Access Compliance Report

Public Rights-of-Way

(Curb Ramps)

Intersection ID: 12517	Main Street: N_SHARON_AMITY_RD	Cross Street: SHAMROCK_DR	Location:	E
ADA ID: 324F08921B7C	Ramp Type: Perp	Initial Pass/Fail: Fail	Overall Compliance: No	Severity Score: 12.5
Codes/Mitigation Info/Possible Solution		Field Measurements/Component Compliance

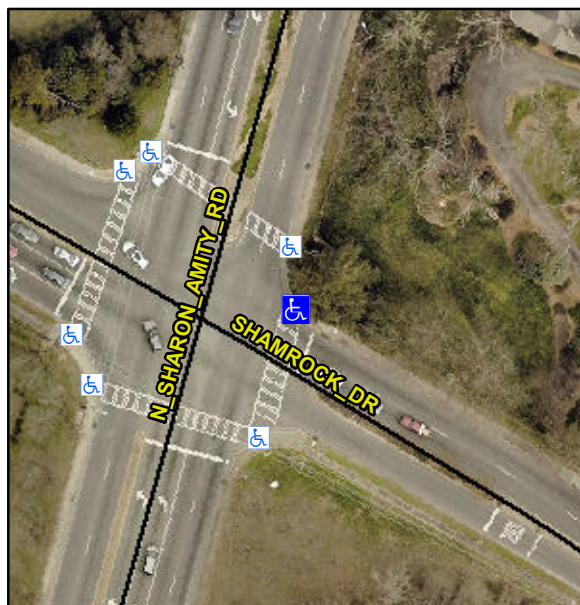
Not Found, R304.2.2

Compliance	Description	Data	Compliance	Description	Data
N/A	Ramp Length (in)	59.5	No	Ramp Slope (%)	9.3
Yes	Ramp Width (in)	48.0	Yes	Ramp XSlope (%)	0.1
N/A	Flare Type LT	N/A	N/A	Flare Type RT	N/A
N/A	Flare Slope LT (%)	N/A	N/A	Flare Slope RT (%)	N/A
N/A	Flare Traversable LT?	N/A	N/A	Flare Traversable RT?	N/A
N/A	Landing Length (in)	N/A	N/A	DWS Provided?	N/A
N/A	Landing Width (in)	N/A	N/A	DWS Contrast?	N/A
N/A	Landing Slope (%)	N/A	N/A	DWS Length (in)	N/A
N/A	Landing X Slope (%)	N/A	N/A	DWS Full Width?	N/A
N/A	Landing Curb? (Y/N)	N/A	N/A	DWS Offset (in)	N/A
N/A	Shared Landing?	N/A			
N/A	Gutter Ponding?	N/A	N/A	Gutter Slope (%)	N/A
N/A	Gutter Lip Ht (in)	N/A	N/A	Gutter X Slope (%)	N/A
N/A	Painted X Walk1?	Yes	N/A	Painted X Walk2?	N/A
	X Walk 1 Direction	To SW		X Walk 2 Direction	N/A
N/A	X Walk 1 Width (in)	117.5	N/A	X Walk 2 Width (in)	N/A
	X Walk 1 Slope (%)	0.2		X Walk 2 Slope (%)	N/A
	X Walk 1 X Slope (%)	1.1		X Walk 2 X Slope (%)	N/A

Remove & Replace Entire Ramp.
